September 10, 2016 Penneco Response to NOD Letter

Notice of Deficiency Response

Underground Injection Control Program
Class IID Injection Well Permit Application

Sedat #3A

Map 3. Riddlesburg Shale Isopach Map

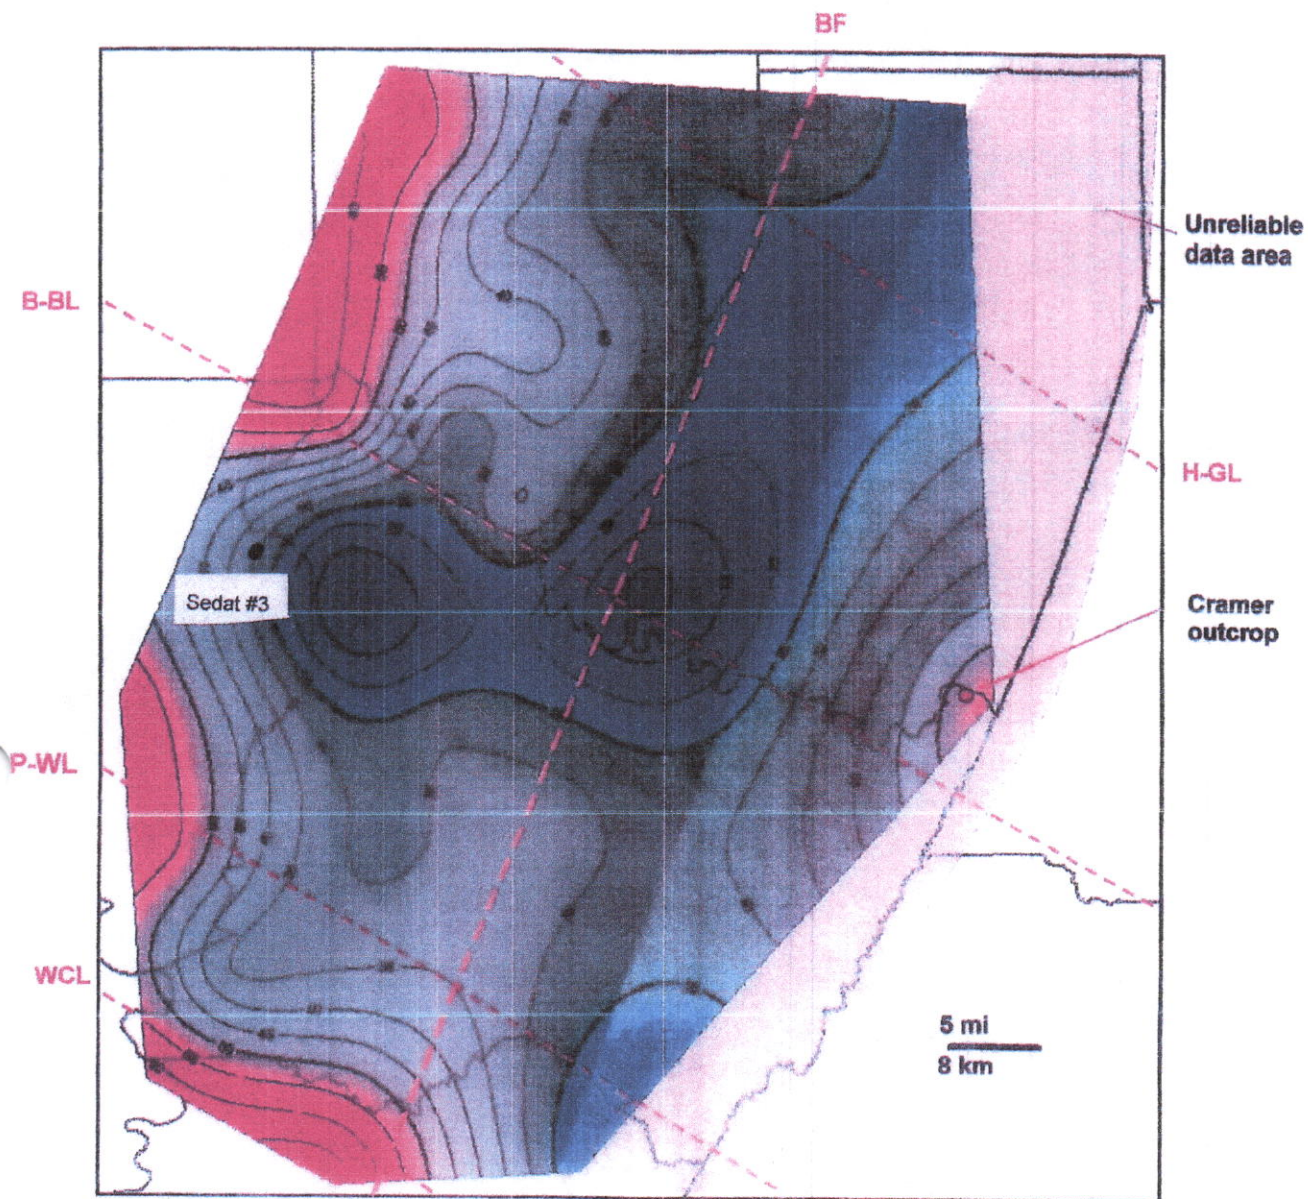
their report. To address Item 8 the geological narrative has been revised so that it now includes an additional structure map contoured on top of the Murrysville Sand, and an additional three (3) cross sections across the AOR showing no sand displacement.

The upper confining zone lying directly on top of the Murrysville is the Riddlesburg Shale. The Riddlesburg is a dark gray to greenish and grayish black laminated shale and siltstone with occasional sandstone and limestone beds. The Riddlesburg is between 80 to 90 feet thick in the Sedat #3A AOR; see the Riddlesburg Isopach map, Map 3 at the end of Attachment G.

Earthquake Map 1

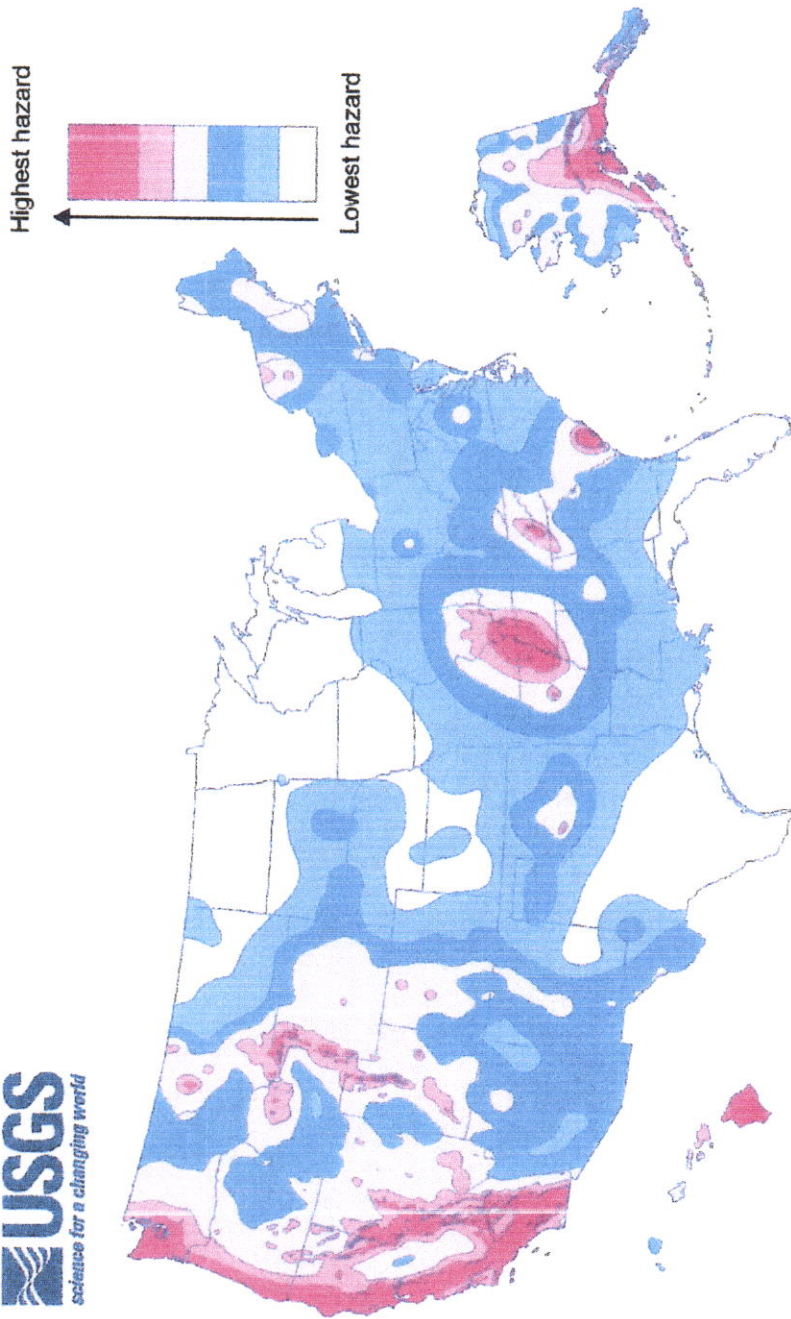
Four seismic maps from the USGS Earthquake Hazards Program were added to the end of Attachment G. Map 1 shows historic seismic activity in Pennsylvania, showing there has been no activity in the AOR. Maps 2, 3 and 4 show the probability of natural or induced seismic activity in different formats. All three show low probability of any activity in the AOR.

Earthquake Map 1 shows the historical locations of earthquakes in Pennsylvania and nearby areas. Earthquake Map 2 shows the entire US color code to show the chance of a seismic event occurring from lowest to highest. Map 1 shows no seismic events are shown to have occurred in SW PA, and Map 2 shows the AOR lies in an area with the second lowest hazard level.
